ALERT SERVICE BULLETIN
Bell Helicopter **TEXTRON**

NO. 407-06-72

MODEL AFFECTED: 407

SUBJECT: HORIZONTAL STABILIZER 407-023-801-109,
INSPECTION AND REPLACEMENT OF

Figure 1 – Horizontal stabilizer, first inspection and 600 hour / annual inspection

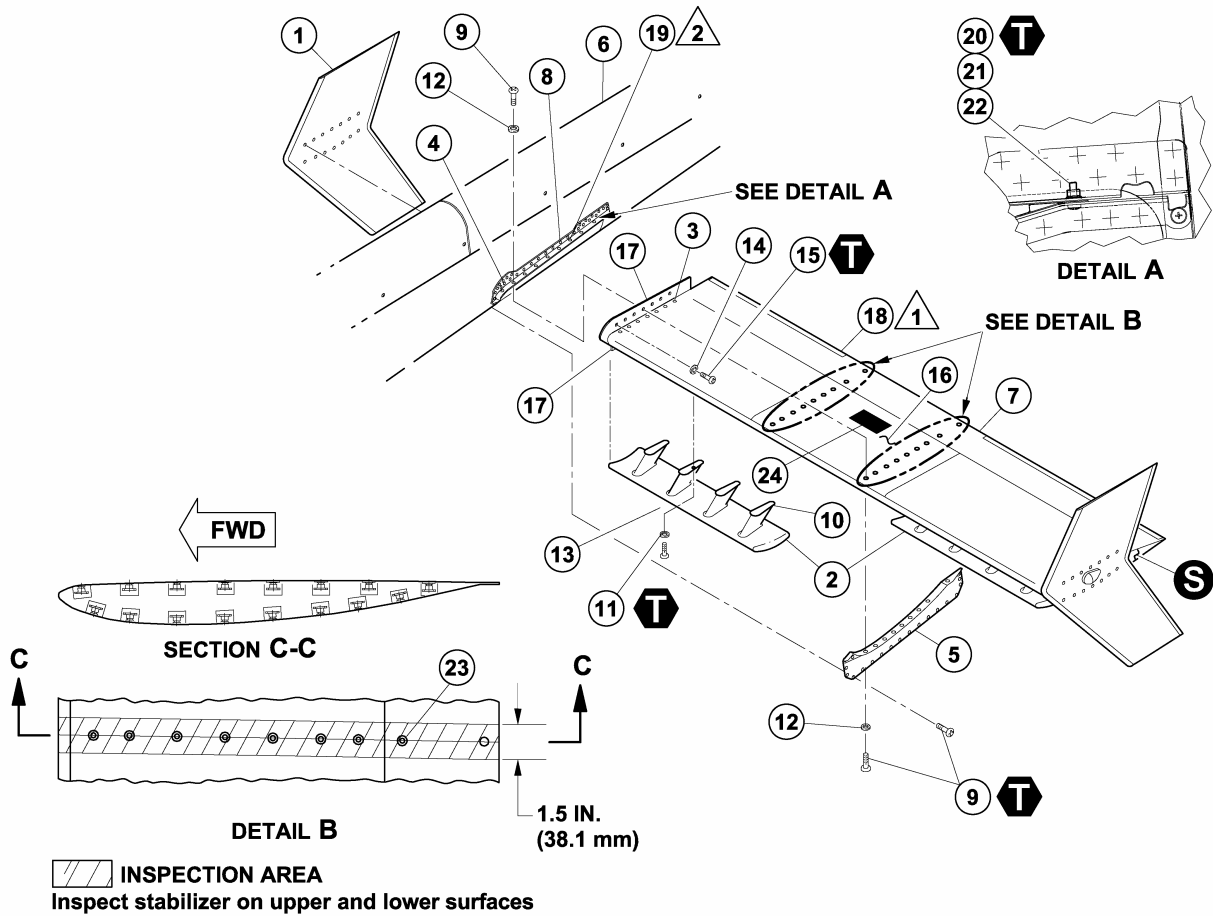
It has been determined by Bell Helicopter that the horizontal stabilizers 407-023-801-109 as listed in Table 1, may have flaws present on the inside surface of the upper and/or lower skin at the tailboom attachment inserts area. Over time the flaws may produce cracks in the upper and/or lower skin.

6. Carefully lower stabilizer (7) and move to left side.
7. Refer to Figure 1 Detail B. Clean and prepare surface of the stabilizer for inspection using cheesecloth (C-486) moistened with acetone (C-316).

8. Inspect stabilizer in area of the inserts (23), on upper and lower surfaces for cracks and deformation using a 10X power magnifying glass. Inspect the area around each inserts and between inserts for debonding using tap test method.

9. If any damage is found, the stabilizer is not repairable. Accomplish Part III immediately.
10. If no damage is found, continue with the inspection.

1. Remove and retire from service affected horizontal stabilizer. Install a serviceable horizontal stabilizer in accordance with BHT-407-MM-5.
2. Make an entry in the helicopter records to indicate that this bulletin has been accomplished
